January 15, 2026

CONTRACT NO. 1797

OHIO RIVER TUNNEL

ADDENDUM No. 12

Existing 42" Combined Sewer to Existing 48" Combined Sewer Previous Bypass Pumping Locations (For Reference Only)

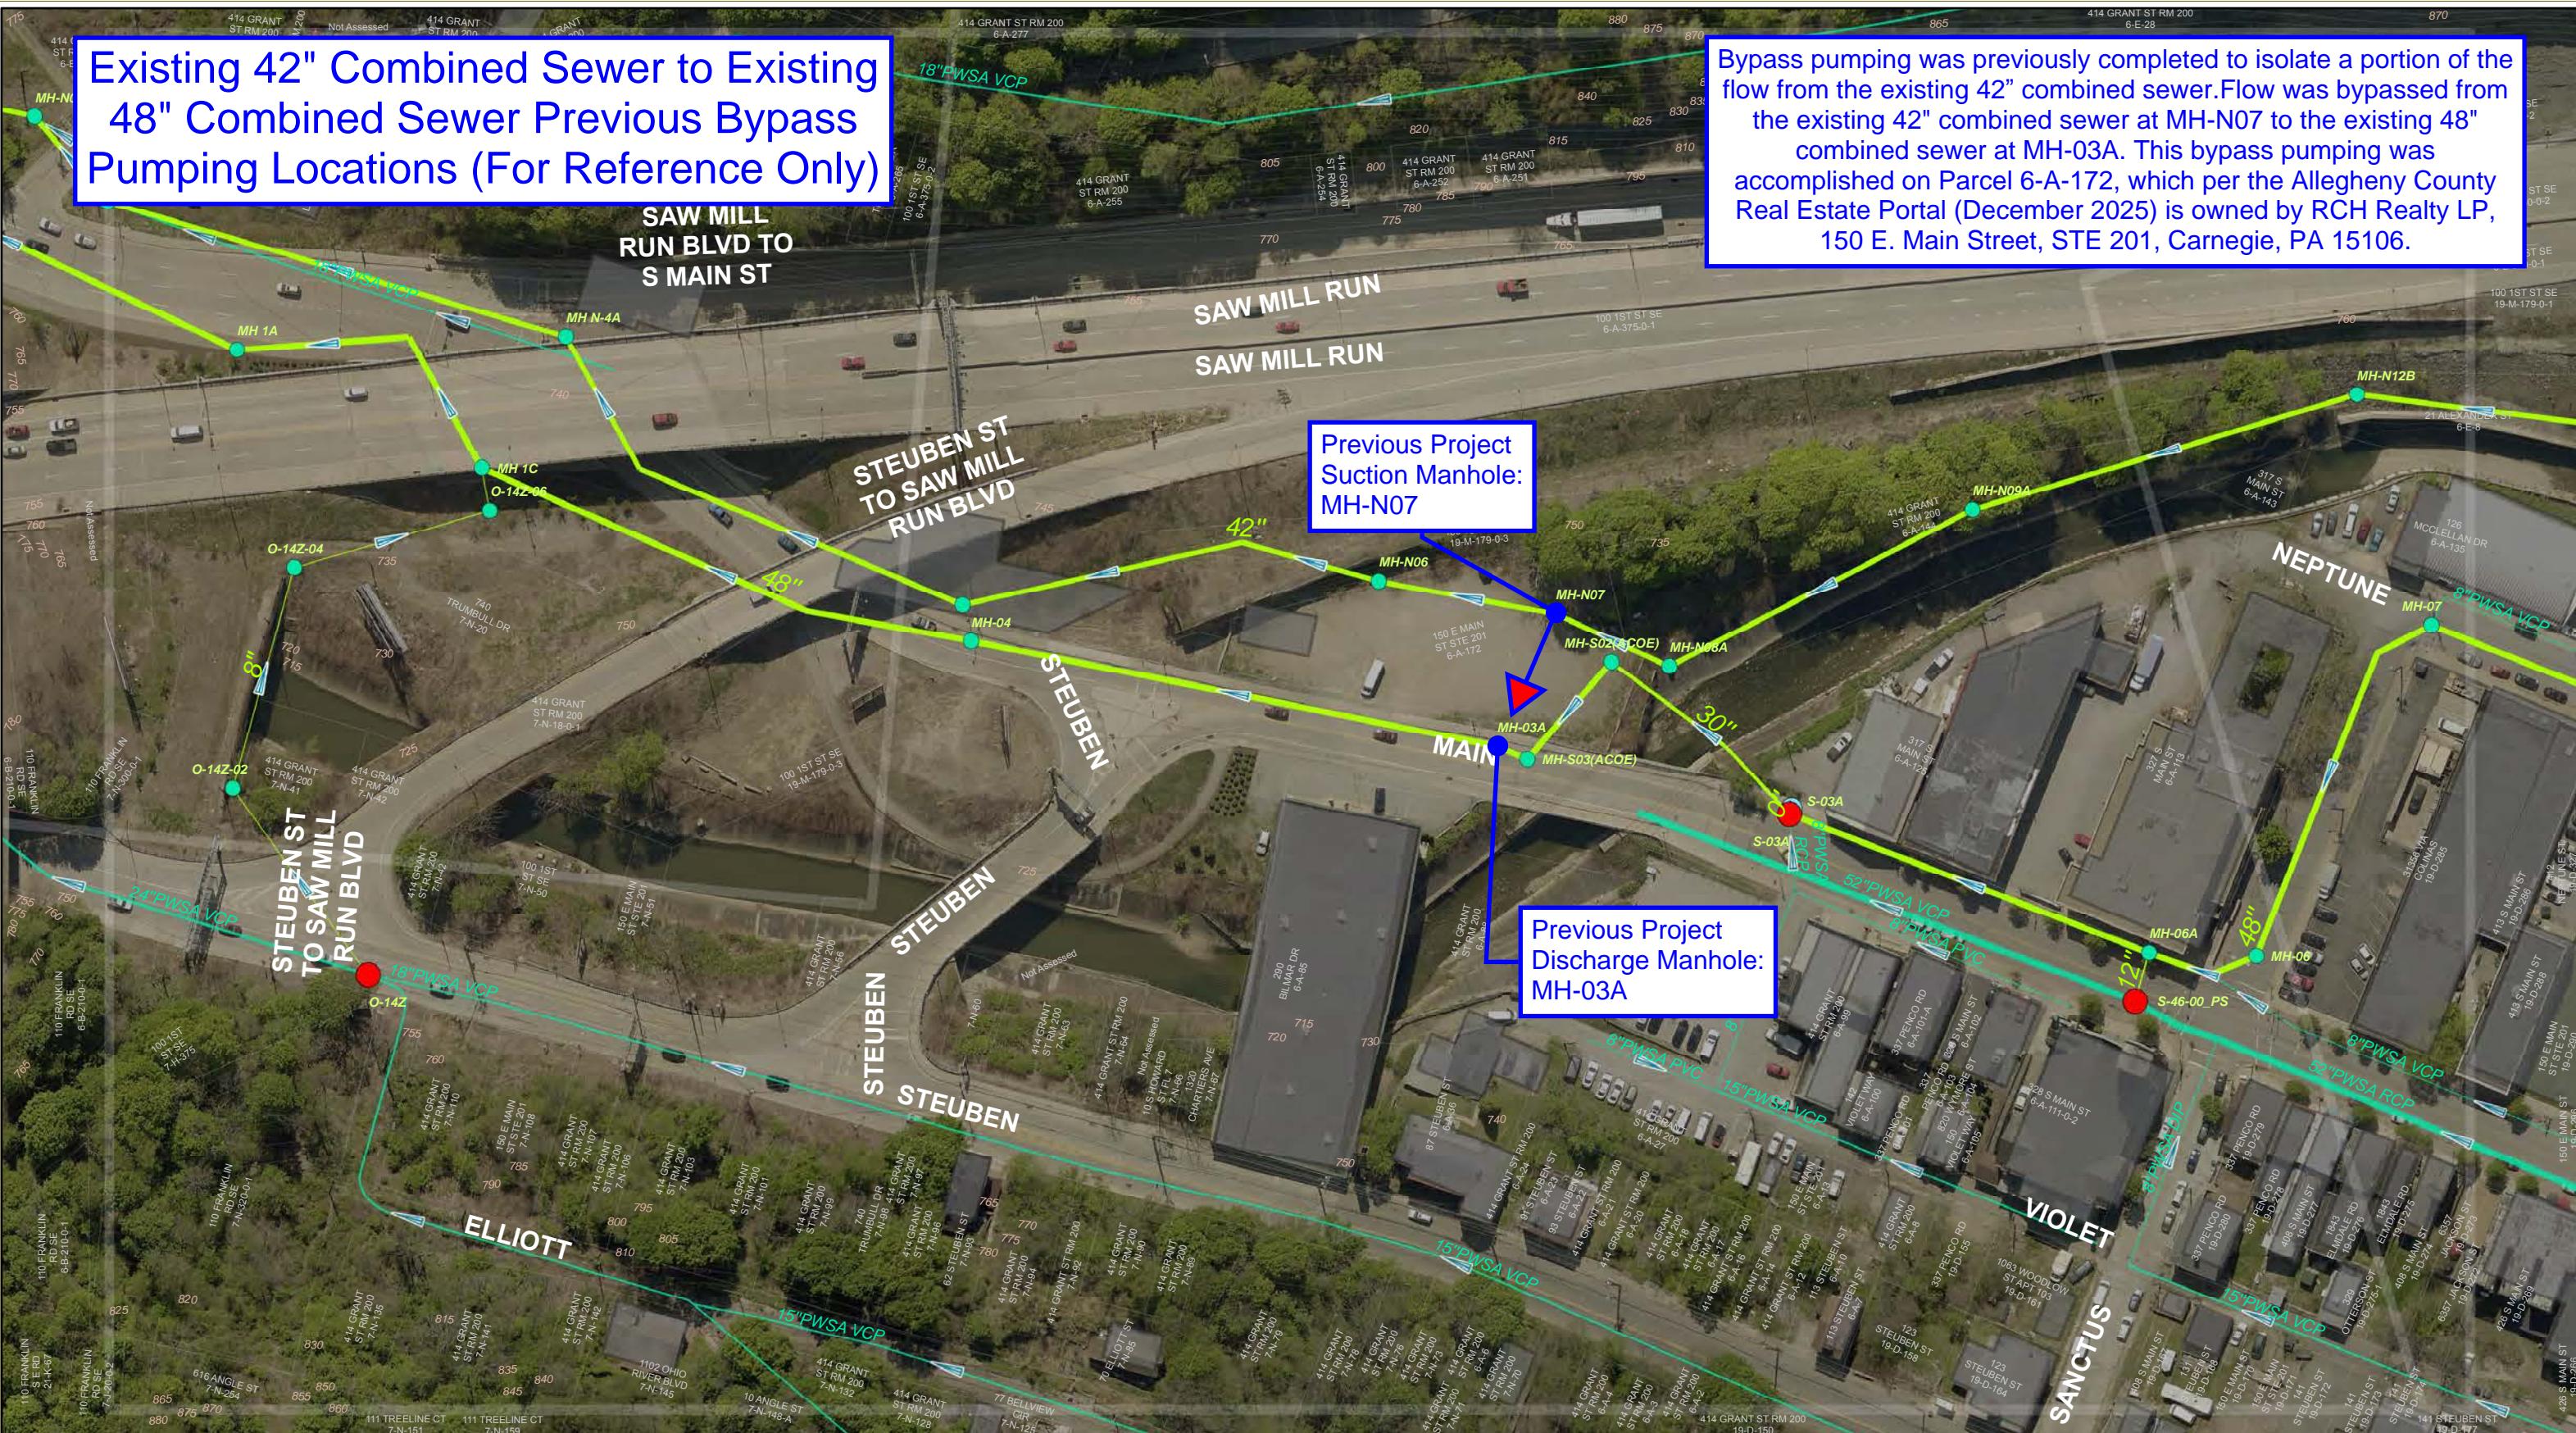
A2 **The Owner has completed previous projects on the existing 42" and the 48" combined sewers that have included bypass pumping at upstream locations previously coordinated with the Owner and other associated property owners. While property owner information is provided, it is the Contractor's obligation to secure appropriate private property permissions, permits and authorization for work on sewers, within the public ROW and near all streams including stream crossings. Referenced locations are included on exhibits: ADDED to APPENDIX E – SUPPLEMENTAL INFORMATION; See Attachment A of this Addendum.**

Bypass pumping was previously completed to isolate a portion of the flow from the existing 42" combined sewer. Flow was bypassed from the existing 42" combined sewer at MH-N07 to the existing 48" combined sewer at MH-03A. This bypass pumping was accomplished on Parcel 6-A-172, which per the Allegheny County Real Estate Portal (December 2025) is owned by RCH Realty LP, 150 E. Main Street, STE 201, Carnegie, PA 15106.
